memorandum

TO Selwyn District Council FROM Chris Bender
DATE 3 September 2021
RE Plan Change 73 – Odour Assessment Review

Figure 1 Proposed Plan Change Area with Separation Distances from Odour Generating Activities

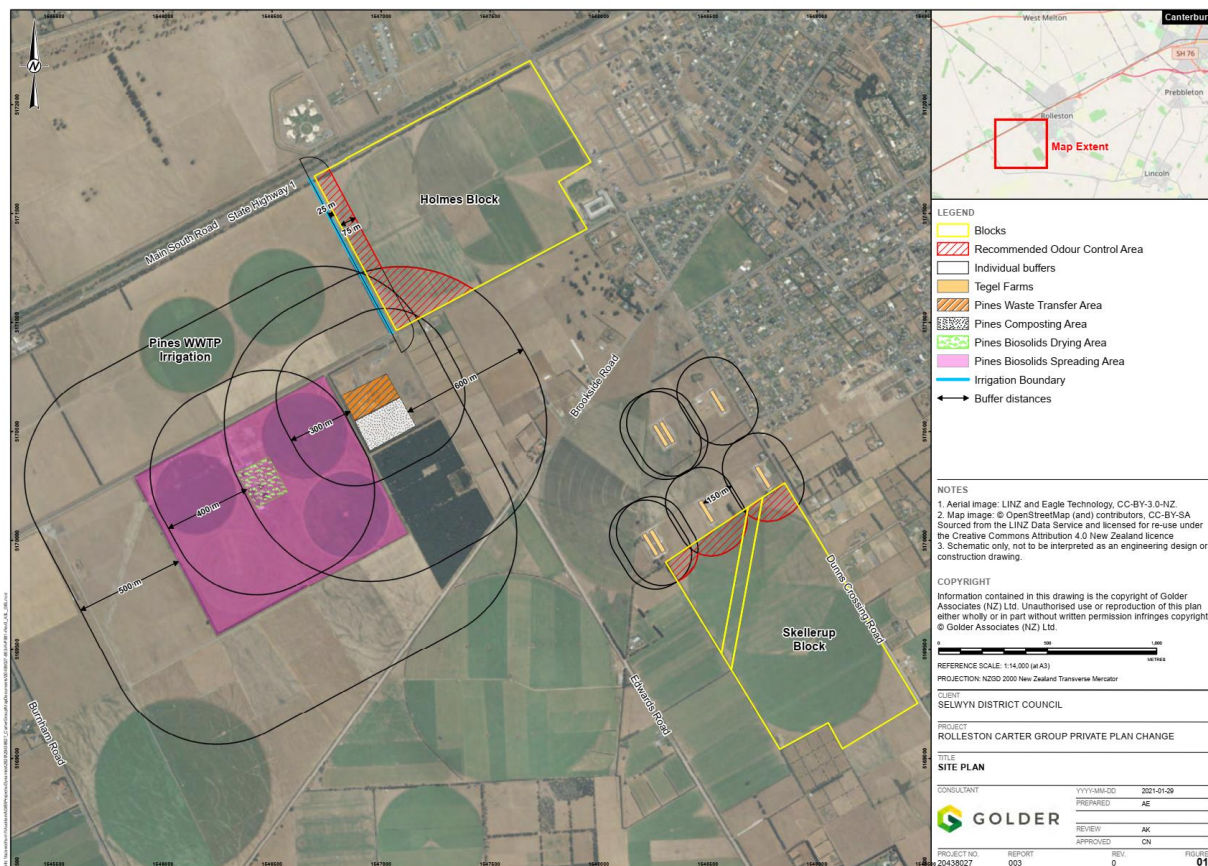
4. The proposed plan change area consists of two blocks of land to be rezoned, referred to as the Holmes Block and the Skellerup Block. The proposed plan change area that has the potential for reverse sensitivity effects on nearby activities are shown in Figure 1 below taken from the Golder report. There are existing activities that have the potential to generate odour. The risk of adverse amenity effects arising due to odour discharges from these activities is potentially increased by the proposed residential development. The existing activities potentially impacted by reverse sensitivity effects are:

26. The applicant has measured the Odour Control Setbacks Areas from the active compost windrows, which I agree have the greatest risk of generating offensive odours. The proposed separation distance of 600 metres results in an Odour Control Setback Area in the southwest corner of the Holmes block extending between approximately 300 - 400 metres within the property boundary of the block. Mature compost windrows are located nearer to the site boundary and are closer to the Holmes Block. The Odour Control Setback Area for the Holmes Block extends to approximately 490 metres from the closest mature compost storage and handling area. The compost windrows are managed to be progressively more mature as they are located nearer to the site boundary.
